CITY OF ALBUQUERO

RE: Ventana Square – Tract H-6B-1 **Grading and Drainage Plan** Engineer's Stamp Date: 09/23/22 Hydrology File: B10D003C3C

Based upon the information provided in your submittal received 10/03/2022, the Grading & Drainage Plan is not approved for Building Permit and for action by the DRB on Site Plan for PO Box 1293 Building Permit and Preliminary Plat. The following comments need to be addressed for approval of the above referenced project:

C-1

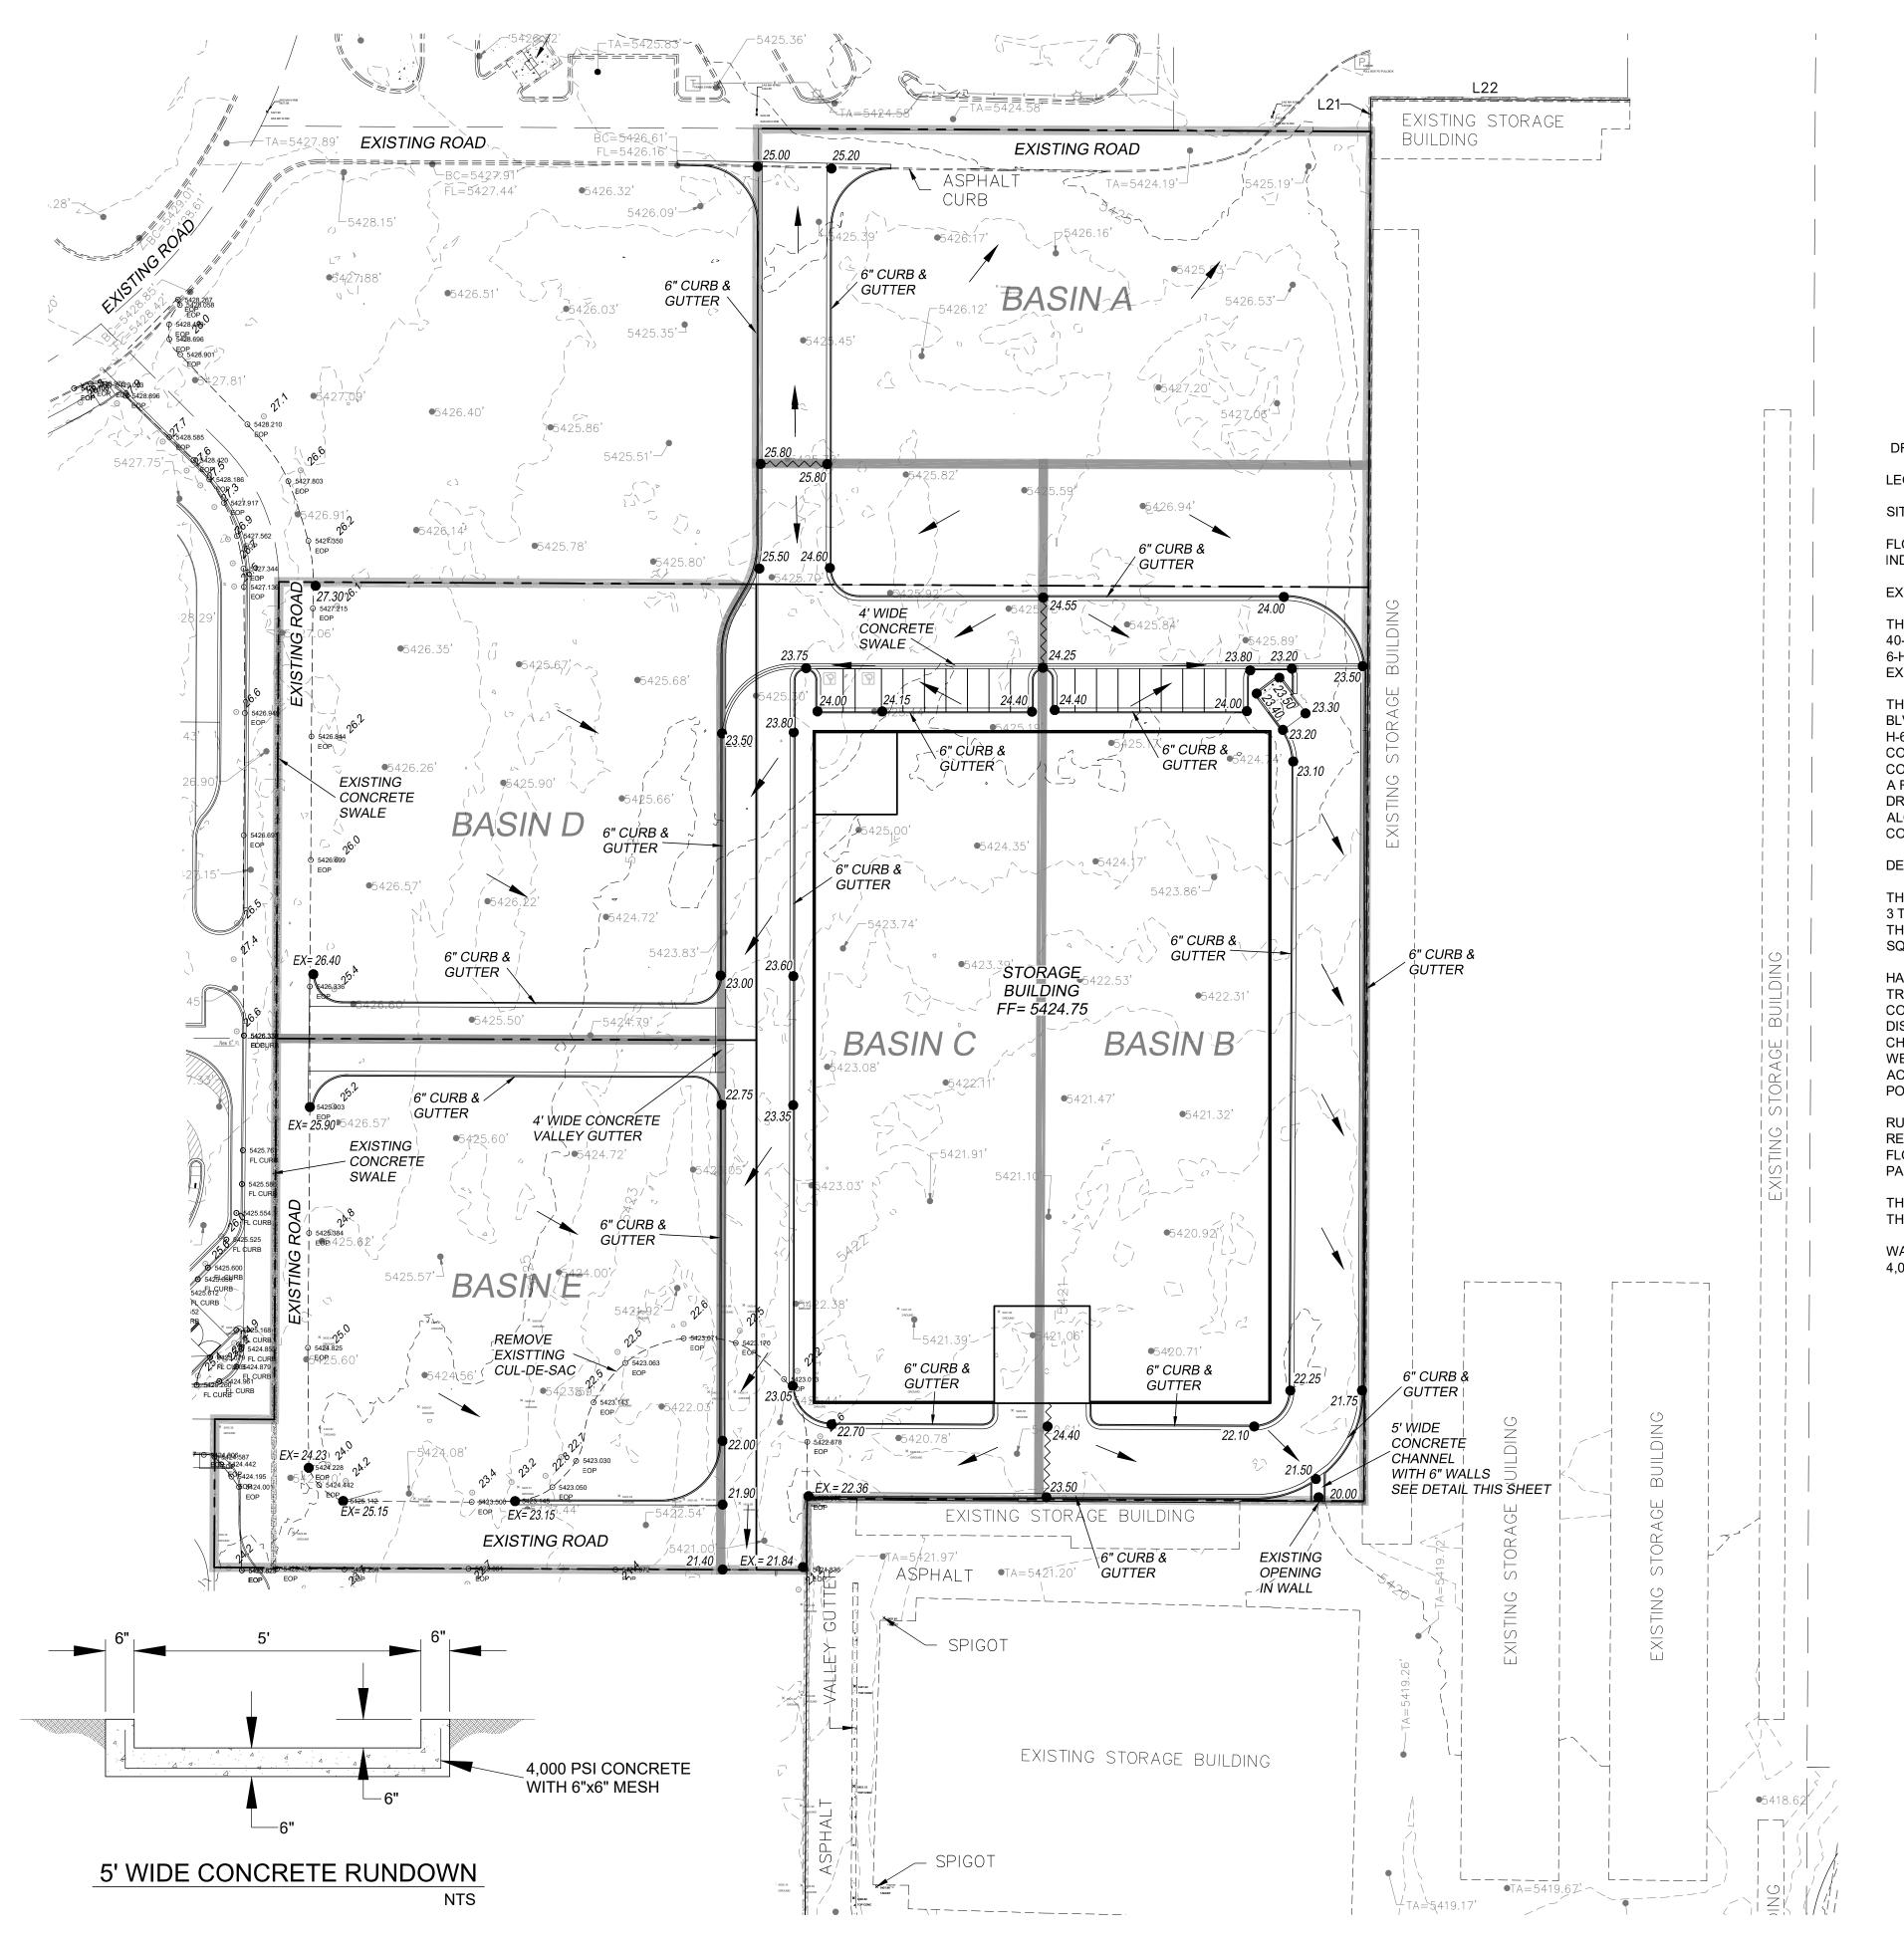
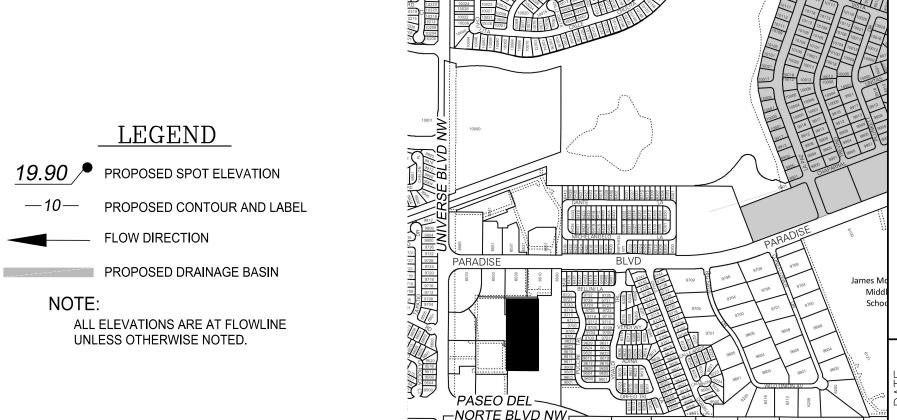
> 1. According to the stamped approved Drainage Management Plan with engineer's stamp date 07/30/21, This project was to drain to the west and not be included within the ultimately discharges into the temporary retention pond.

> designed 14.08 cfs that drains through an existing swale to the concrete channel which

Please adjust Basin C's drainage pattern and drainage calculations for this site to reflect this.
